CITY OF CALGARY

ITEM: § 1./0 CPCQOQ1-0873

PRIMARY CONCERNS

RE: DP2020-6663 | 1110-1126 Gladstone Road NW | DP Amendment Application

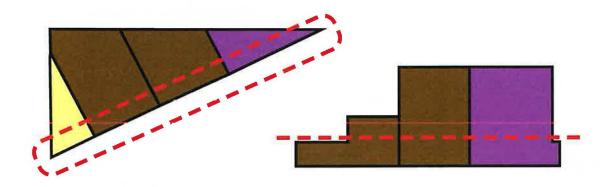
3. The development should be sensitively designed in its form, height, scale, and level of articulation which blend into its directly adjacent context. The grade level units can be designed to take the form of at-grade townhouses with vertical façade modulation. In this way a 2-3 storey high podium with good street presence along Gladstone Rd NW is created.

- 13. Consider an upper level stepback to create a better transition, to break down the building mass and lower the scale and to have less shadow impact on the properties north of the subject site. The top two floors should be stepped back ...
- 17. Step back upper levels (preferably starting from 2nd or 3rd level) to reduce the perception of height along the street and respect and reinforce the height and massing established by surrounding low-density context.

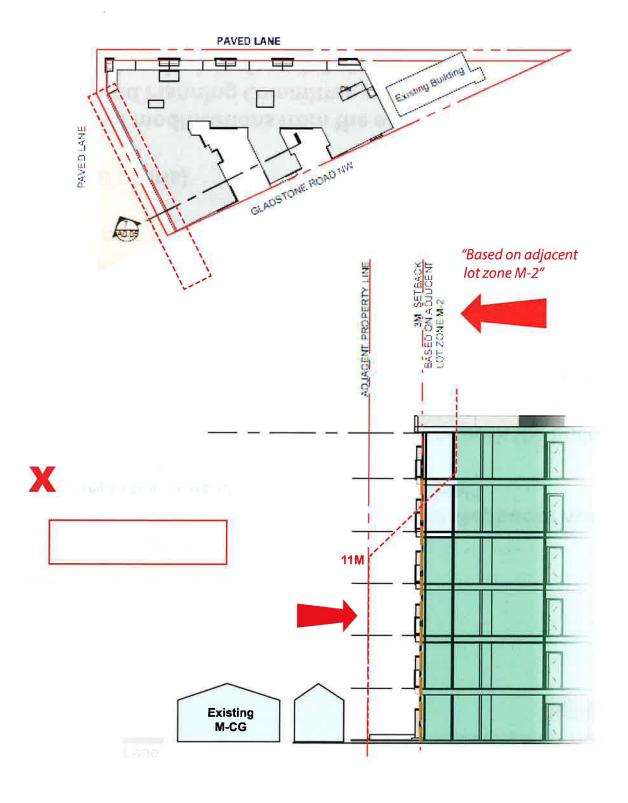
UDRP "Plans indicate the west elevation as being within the height chamfer."

No step-back shown.

Developer argues that it isn't required because of *proposed* M-C2 parcel adjacent.

Currently this parcel is M-CG

No application is in and the ability to achieve 5 storeys on this parcel is arguable.

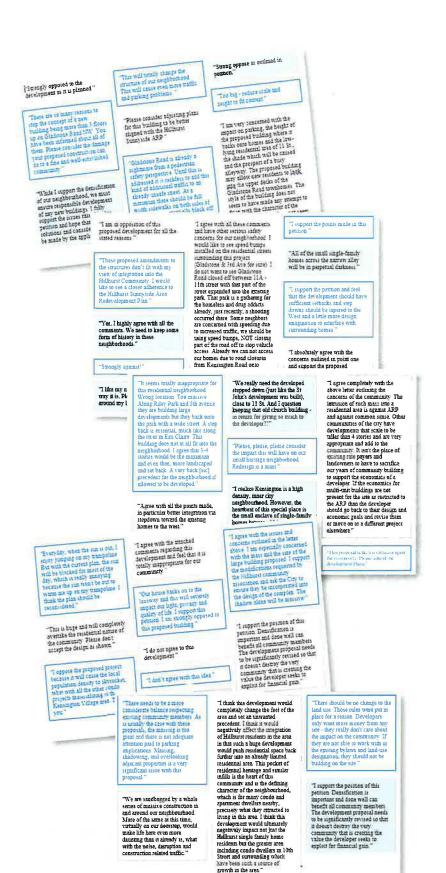
"The concept drawings appear quite monolithic; a podium and stepbacks would be an effective way to help minimize the building massing at street level."

"We request wording added to the Direct Control district rules to push the building massing inward at the upper floors... where property lines abutting the lower density M-CG districts immediately to the west, north and south are to be set back and tiered back as appropriate."

"There is a strong preference from neighbours and HSPC to further **step down the building closer to the interior residential part of the community.** Community members cited the positive precedent set by the St. John's Condo building built in 2011..."

"There appears to be very few modifications from the original design and as such, does not address the DTR and Planning Committee suggestions regarding step downs and setbacks, softening the interface, 2-3 storey townhome design at the laneway, set back from Gladstone Road, etc."

"Significant community consultations resulted in the current ARP maximums to ensure sensitive transition from the community Main Streets to the lower density residences to the west. This context has not been demonstrated with the current proposed development."

DC MASSING OUTCOME

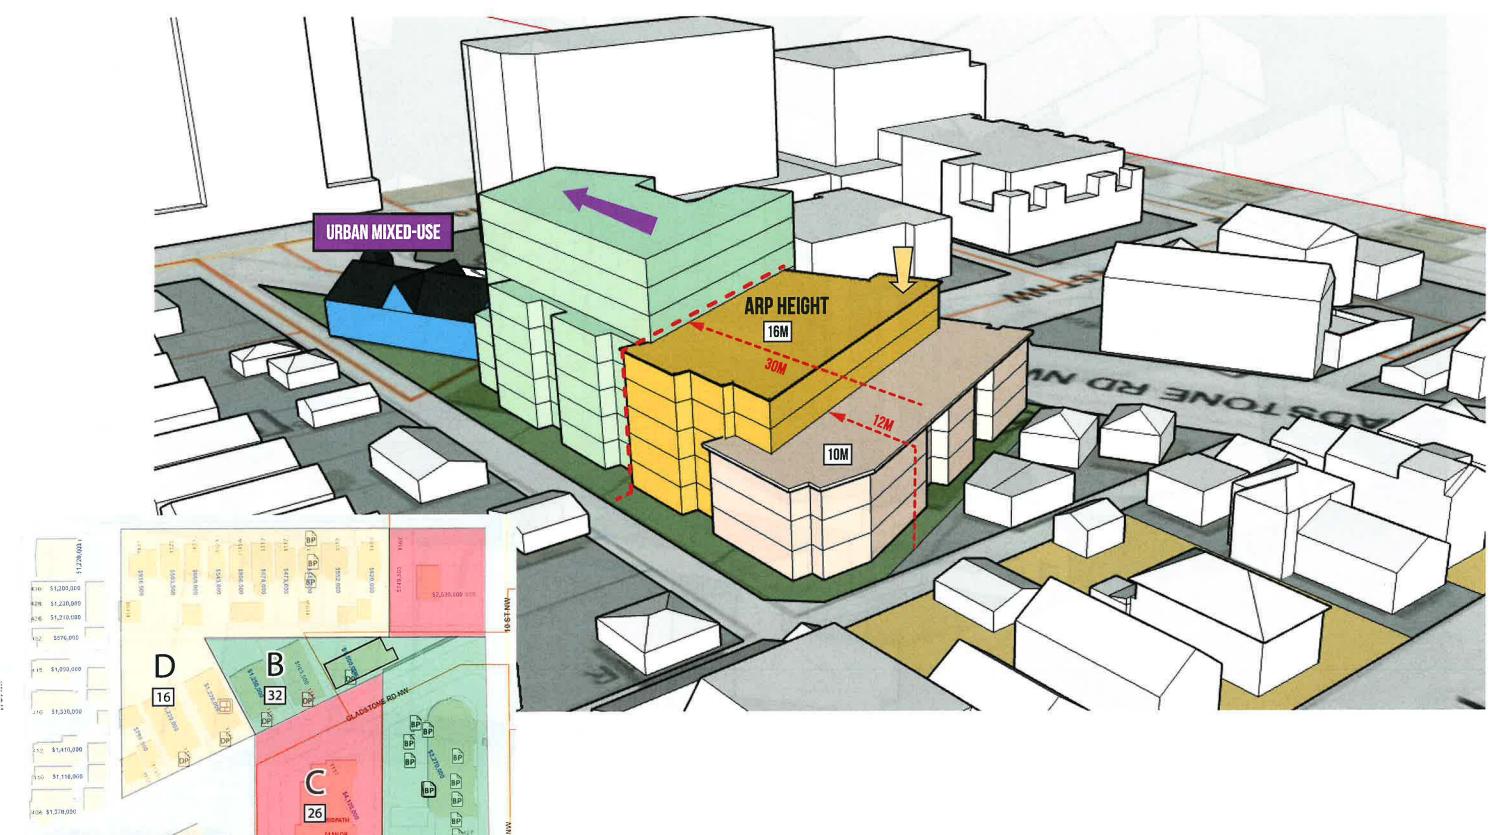
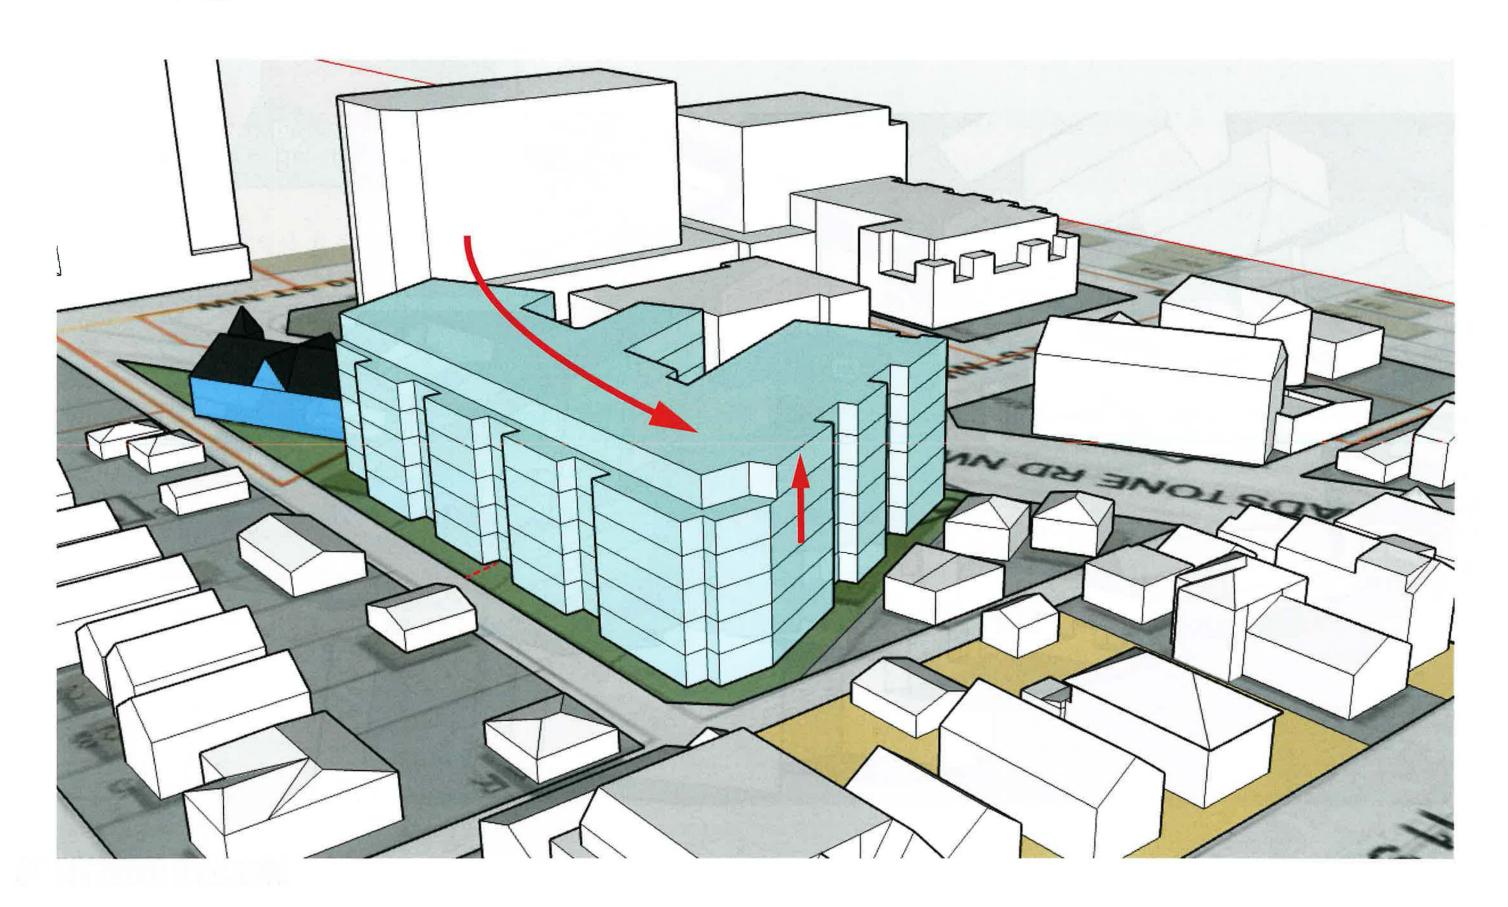
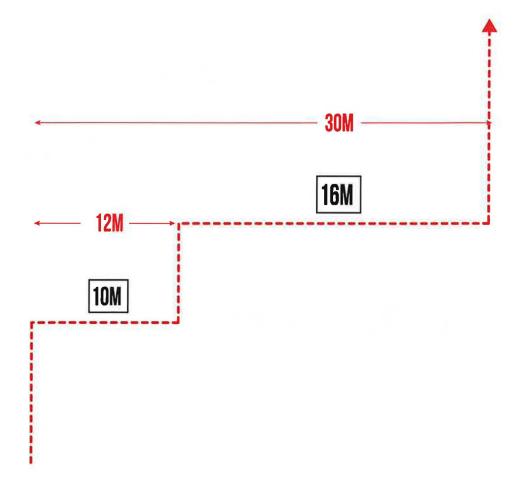
Proposed depth of step-backs works with the existing plans requiring **moderate redesign** to achieve respectful massing and ARP compliance.

- Allow for sensitive redevelopment of a parcel that is larger in size and with greater parcel depth than the majority of other parcels on 10th Street NW;
- To create a built form where building height transitions from high to low from 10th Street NW to the low density residential development;

Building facade facing Gladstone Road must provide a cornice line of 3 storeys or a maximum height of 10.0 metres with a step-back of 3.0 metres.

★ Where the parcel shares a property line on the west with a parcel designated as a low residential or M-CG district, the maximum building height referenced in subsection (1) is reduced to 10.0 metres measured from grade within 12.0 metres of the property lines rising to 16.0 metres maximum height for 30.0 metres from the shared property lines.
